TECHNICAL PUBLICATION REVISION

REVISION NO.	PUBLICATION	PUBLICATION NO.	PUBLICATION DATE
60294-7-14	Direct Drive Overhaul Manual	60294-7	December 1974
The page(s) in this revision replace, add to, or delete current pages of the publication indicated above.			
PREVIOUS REVISION		CURRENT REVISION	
April 1966		July 2011	
5-3, 5-6; 8-5 July 1967		7-10D	
5-8; 6-1 thru 6-18, 6-23, deleted pages 6-25 thru 6-32			
April 1968			
4-2 thru 4-8			
December 1968 Section 11 replaced Special Tool Catalog			
January 1970			
i, ii, deleted pages iv and v; 1-1, 1-2, deleted pages 1-3; 2-1			
thru 2-6, deleted pages 2-7 thru 2-12; 3-1 thru 3-5; 4-1; 9-1, 9-2, 9-4, deleted page 9-7; 10-1 thru 10-36, deleted pages			
10-37 thru 10-47			
January 1971			
i, ii; 6-19 thru 6-24; 7-1 thru 7-19; 9-3, 9-5, 9-6 May 1972			
Added page 2-7; 3-1, 3-5; 5-1 thru 5-11, deleted pages 5-12, 5-13, 5-14; 6-1, 6-17, 6-18, 6-22, 6-23; 8-1 thru 8-6, deleted pages 8-7, 8-8; 9-3

Figure 7-12F. Rear End View of Crankshaft Showing Associated Parts

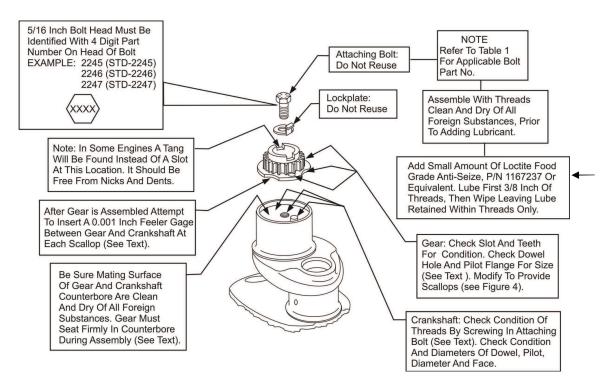
No field repair of crankshaft gear attaching threads is permitted. Crankshafts requiring this type of repair must be returned to the factory through an authorized Lycoming Distributor.

Figure 7-12G. Minimum Dimension of Crankshaft

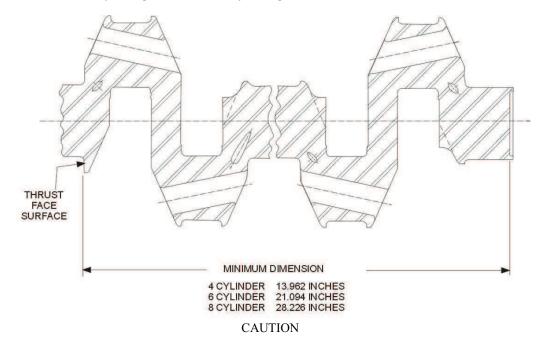
Insure minimum dimension is measured between thrust face surface and pilot.
